HX3.7 MC (SAM5504) Version 2

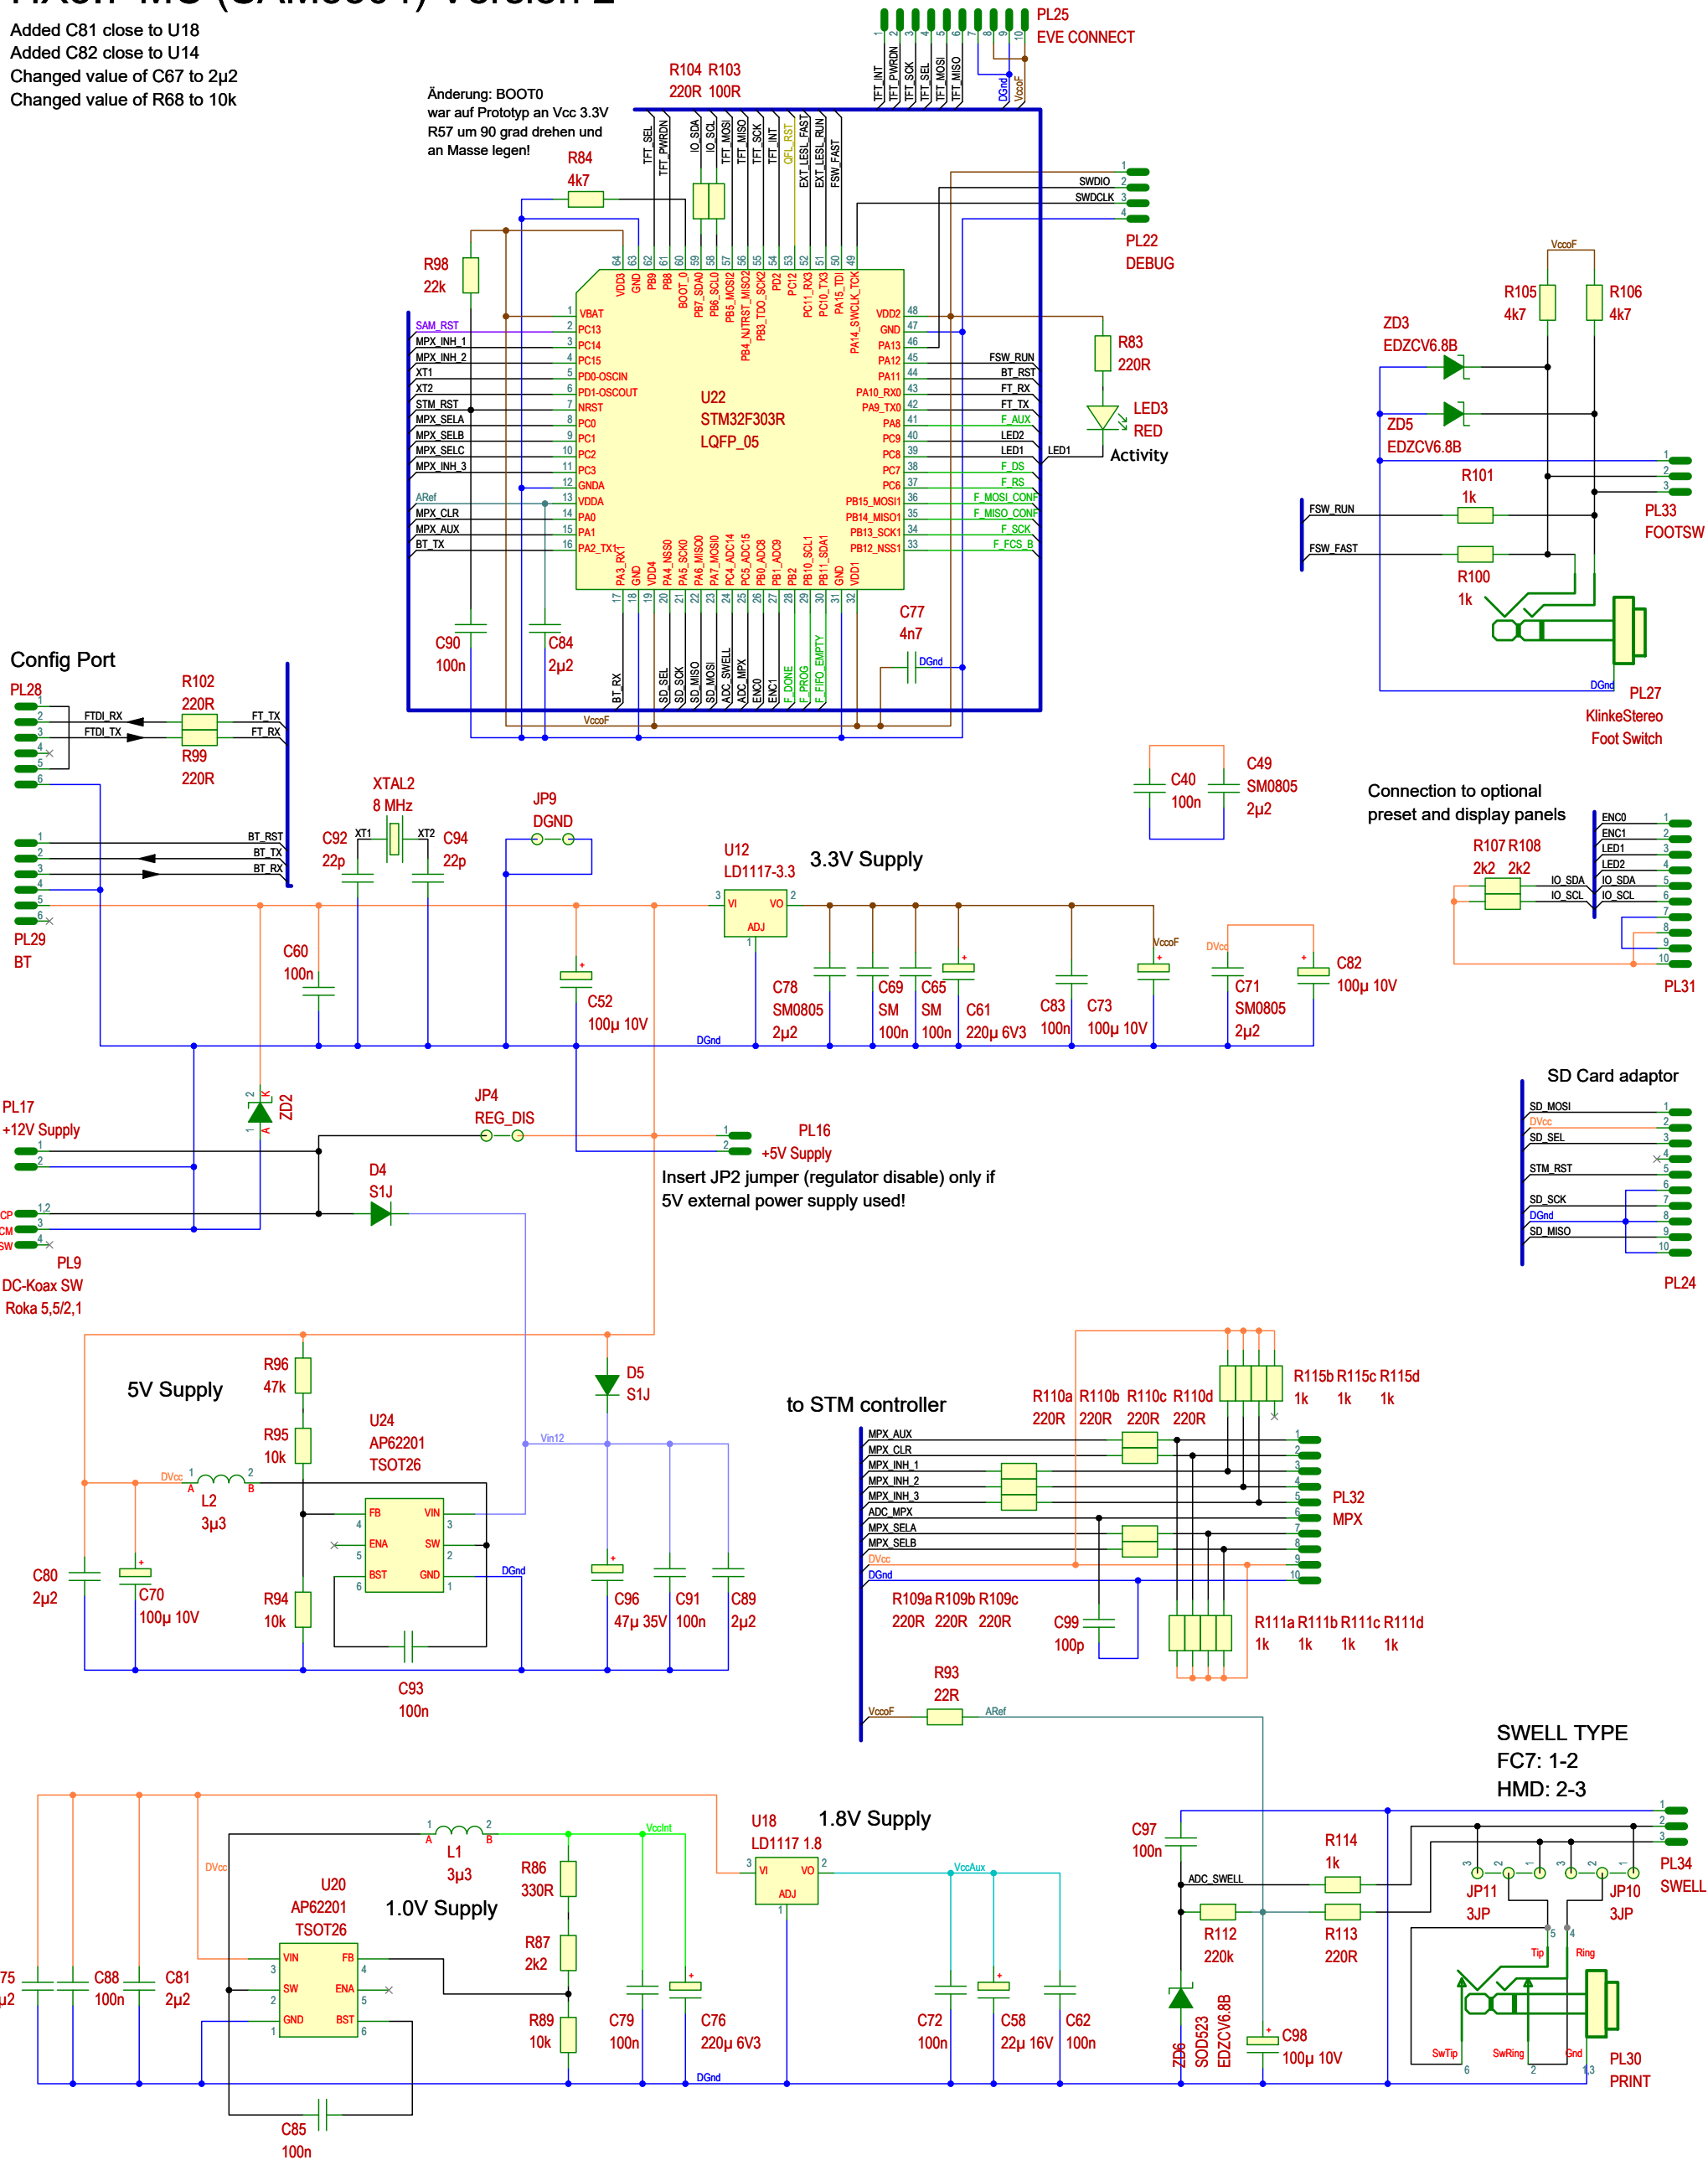
Added C81 close to U18
 Added C82 close to U14
 Changed value of C67 to 2µ2
 Changed value of R68 to 10k

Änderung: BOOT0
 war auf Prototyp an Vcc 3.3V
 R57 um 90 grad drehen und
 an Masse legen!
